Planning Commission Vote Report

Meeting Date: October 09, 2017

Petition: **P.Z. 07-2017 Chesterfield Valley Motor Sports (17501 N Outer 40 Rd):** A request for an amendment to an existing "C8" Planned Commercial District for a 3.0 acre tract of land located north of North Outer 40 Rd west of its intersection with Boone's Crossing (17U510051).

Preliminary Development Plan

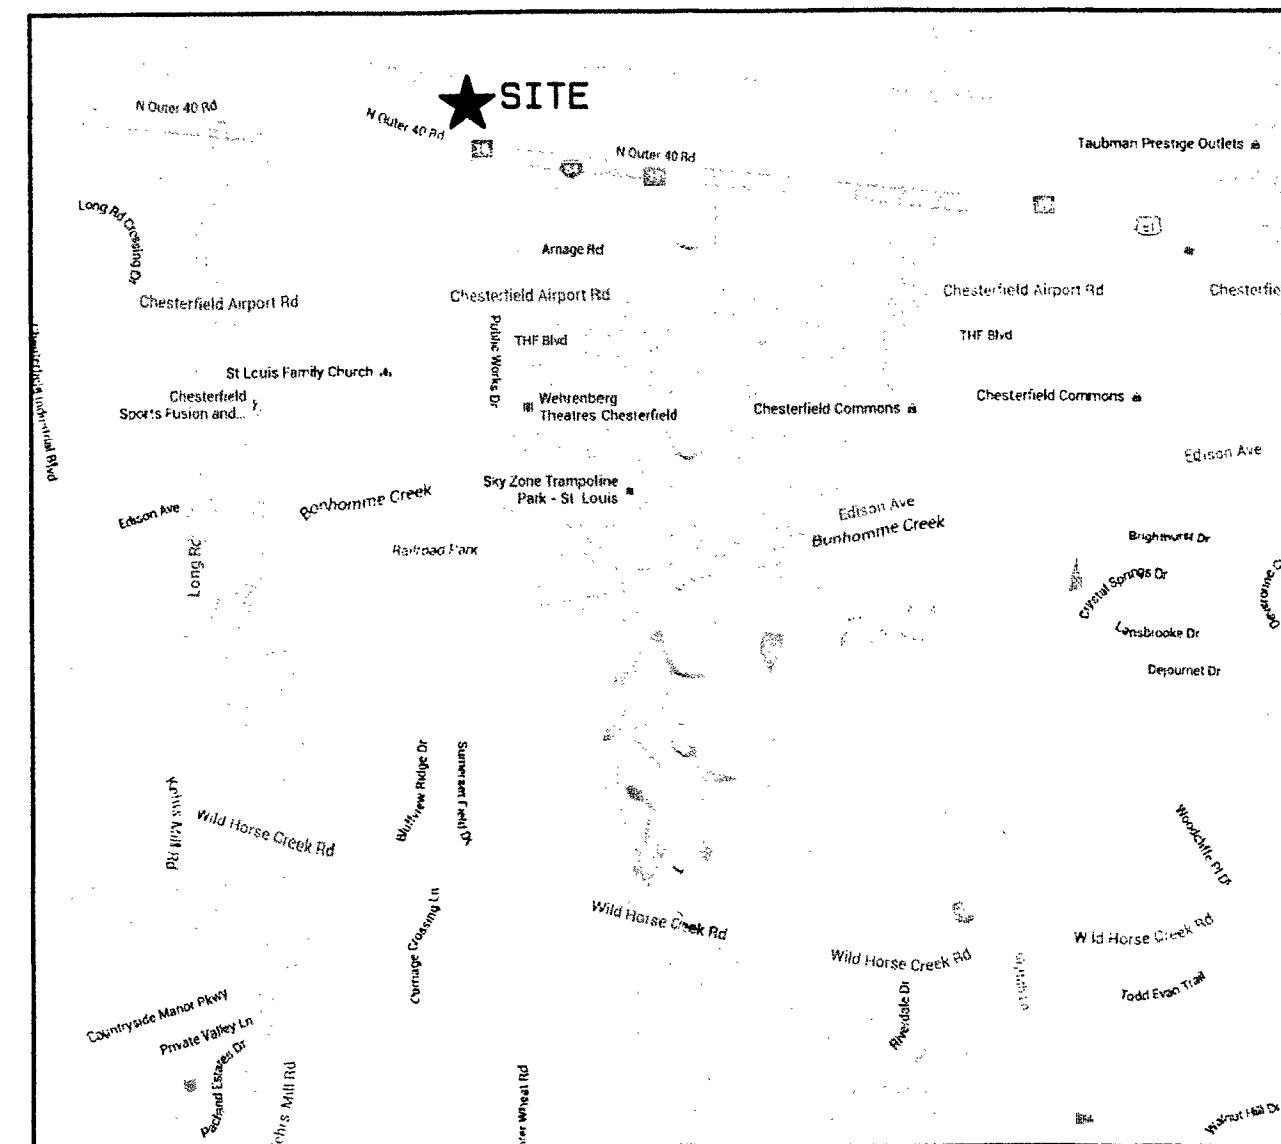
1. Concern was raised regarding the display area(s) in front of the 50' building line and Parking setback. Ensure that no display areas are located within parking setbacks, or provide justification as to why this is appropriate.
2. A request was made for a sight barrier from the Levee Trail.
3. The Commission expressed concern about the type of display proposed. Detail the number of vehicles and/or total square footage of display requested and type of items requested to be displayed.
4. A concern was raised about the length of time that it has taken to pursue compliance.

- The display area described as existing has not been previously approved. Please remove the label Existing Display Area and mark and proposed.
- There is a tree located within a proposed display area. Identify the measures that would be taken to ensure there is no impact on the existing trees.

- You previously indicated that the septic system proposed on the last plans had never been installed, however, a note on the latest plan states that the septic system near the rear of the property is currently not in operation. If the system was never installed, remove the note. If the system was installed, show the location on the plan.

Regarding point 1. This was an oversight on our part. The display area will not impede on any of the required setbacks.

Regarding point 2. Our plan is to replace the chain link fence with wood slat fence that will provide the requested site barrier.

The label on the plans will be changed to reflect proposed rather than existing. The tree that is within the proposed display area will be preserved. Within the proposed area, we will landscape around the tree to ensure that nothing encroaches on it and that it remains unaffected. And my understanding of the septic system was that somewhere on the property, when the building was first built, was a septic system. The building has since been put onto the public sewer system. This was done prior to my acquisition of the property.
